Technical Service Bulletin: tsb100685

Released Date: 23-May-2008

New Injector Load Ring

Old injector load ring (left) and new injector load ring (right)

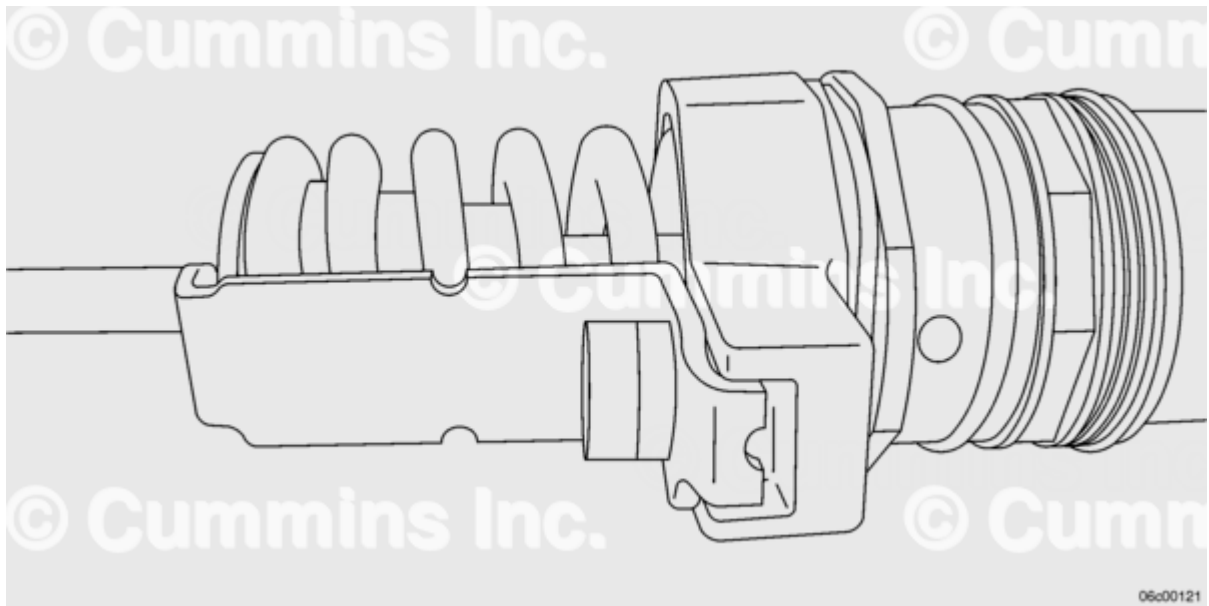
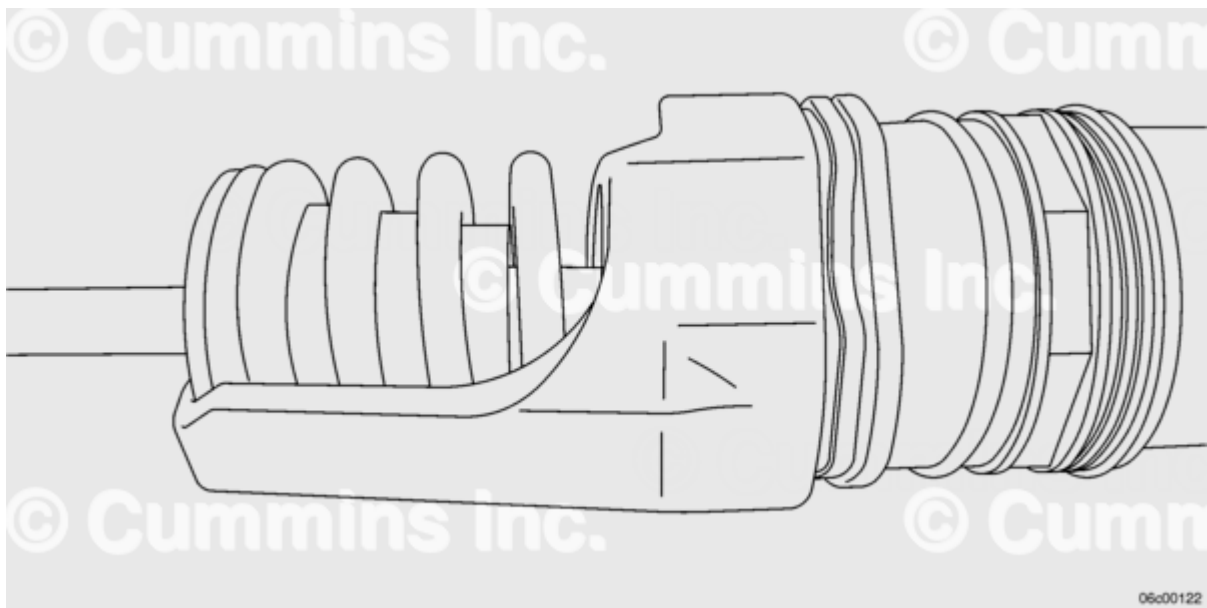
The load ring is located on the top of the fuel injector body and includes the spring retainer. This change is being made to conform the injectors to multiple applications and to increase component robustness. The new injector load ring can be used in all applications; therefore, new replacement injectors will come with the new load ring and will be different in appearance. Remanufactured injectors may come with either load ring. Running an engine equipped with a combination of old and new load rings will cause no adverse effects. See the illustrations below for a comparison of the old and new injector load rings.
